Amphenol PCD

Engineering Change Request		ECR Number	R10541W
Initiator:	Domen	Date:	2026.07.30
Part number description			
Item	K3 Code material part numbers	Drawing/ Doc Number	Version of current related document
1	See list		
2			
3			
Reason of change: ☐ Customer requirement (list the feasibility analysis of customer specification: _____) ☐ Supplier request (list the PCR number: _____) ☒ internal improvement ☐ corrective ☐ other <u>Please describe here in detail: To improve compatibility with charging sockets and plug holders on the market that are not fully compliant with the J1772 standard, the locking force of the plug's mechanical latch has been increased.</u>			
Change level and impact assessment (Please tick in the appropriate position)			
Change level	Change content	Concerned area(Shenzhen, Hermosillo, Chennai)	Whether to notify the customer
Level 1	☐ Operator change ☐ Correct the clerical errors of the drawing, BOM, etc., and this change will not affect the production process		☐ It is not necessary to notify the customer for approval

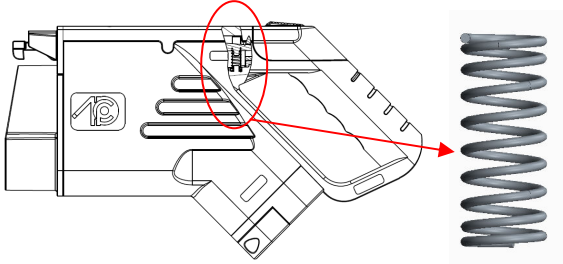
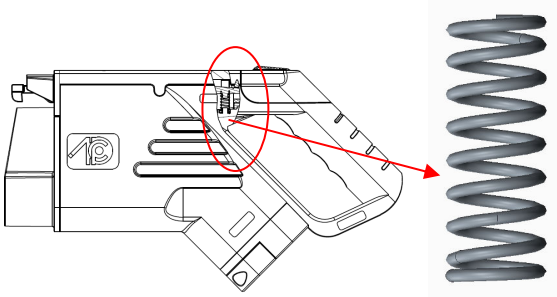
Before change 1./ 	After change 1. Increased Spring Tension 
Disposition of old materials ☐ Rework ☒ Use as it is ☐ scrap ☐ Other (please describe): _____ ☐ N/A	Expect date to switch to new material
Approval by the supervisor of requester.: <i>Jack Derek</i>	Approval by the head manager of the request dept.: <i>Ching</i>
Customer approval: ☐ Approved ☐ No approved ☐ Conditional approval (please describe) : Signature: _____ Date: _____	
Remark:

To improve compatibility with charging sockets and plug holders on the market that are not fully compliant with the J1772 standard, the locking force of the plug's mechanical latch has been increased.
